**Re: Enbridge Gas Inc. (“Enbridge Gas” or the “Company”)
Ontario Energy Board (“OEB”) File No. EB-2022-0157
Panhandle Regional Expansion Project (“Project”)
Responses to OEB and Federation of Rental-housing Providers of Ontario
 (“FRPO”) Additional Requests**

Answer to Additional Request from
Ontario Energy Board (OEB)

Answer to Additional Request from
Federation of Rental-housing Providers of Ontario (FRPO)

With NPS 36 Loop (15.80 km), +58 TJ/d Ojibway Supply
(+168 TJ/d incremental capacity)

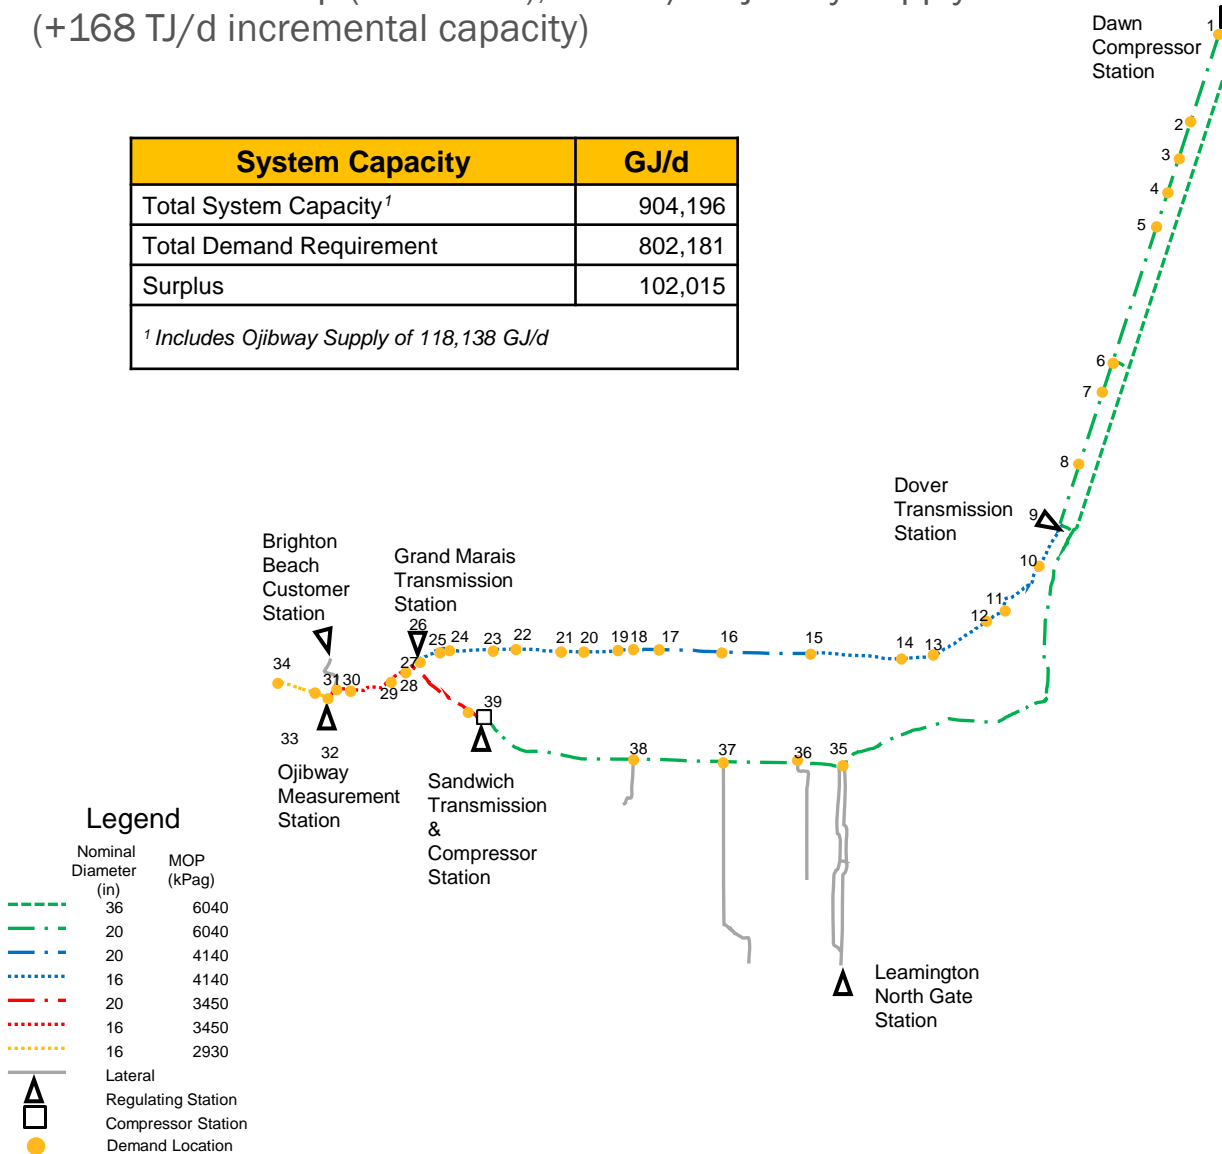
Extend Table 4 to add 37 TJ to the 21 TJ and shorten the length of NPS 36 to a comparable amount of incremental capacity and provide the simulation results in the same format as Exhibit I.FRPO-18. In addition, update the facility cost related to the shortened length of NPS 36 extension.

For *Hybrid Alternative #1 (FRPO Additional Request)* in Table 1, Enbridge Gas evaluated a hybrid scenario which includes a 58 TJ/d firm exchange between Dawn and Ojibway beginning November 1, 2024, for a 40-year term² coupled with an NPS 36 loop of the NPS 20 Panhandle Line. Based on the analysis, the incremental 58 TJ/d of Ojibway deliveries would reduce the length of the NPS 36 loop from 18.93 km to 15.8 km (i.e., 3.13 km shorter than the proposed Project) while providing the same capacity as the proposed Project (168 TJ/d).³ Attachment 1 provides the schematic and table showing the requested pressures and flows related to 15.8 km of NPS 36 with 58 TJ/d of incremental Ojibway supply for Winter 2024/2025.
